**NUMBER:** 23-005-21 REV. A

**This bulletin supersedes Technical Service Bulletin (TSB) 23-005-21, date of issue January 23, 2021, which should be removed from your files. All revisions are highlighted with **\*\*asterisks\*\*** and include an updated parts table.**

Front Seat Side Shield Updated Service Procedure

2014 - 2019 (KL) Jeep Cherokee

**Fig. 1**  
**Back Side Shield Hole Being Elongated**

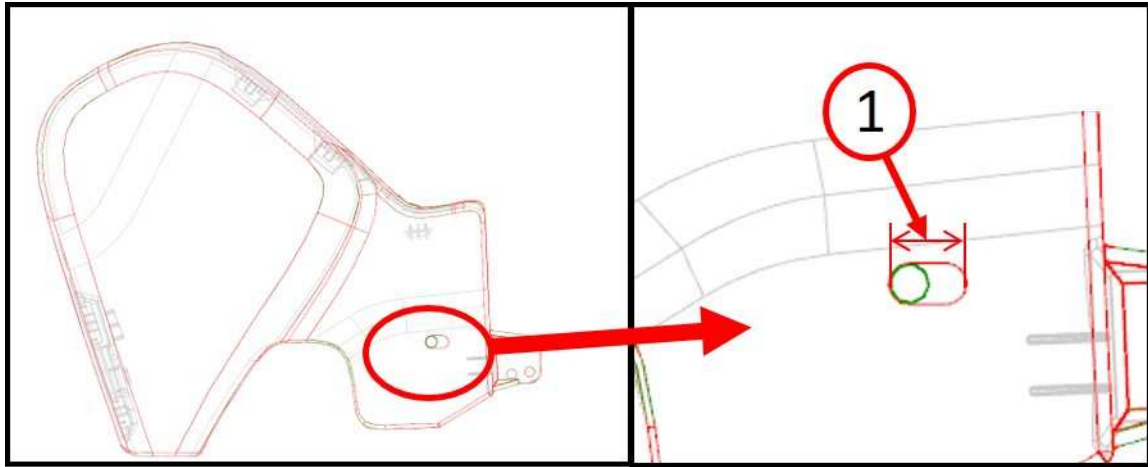
2. Remove inboard side shield. Refer to the detailed service procedures available in DealerCONNECT/Service Library under: Service Info 23 - Body / Seats, Front / Side Shields, Seat, Manual (or Power) / Removal.
3. Use a hand held rotary multi use tool or a file (Fig. 1) to elongate the hole to 12.5 mm (.5 in.) slot (Fig. 2) .

1 - 12.5 mm (.5 in.) Hole
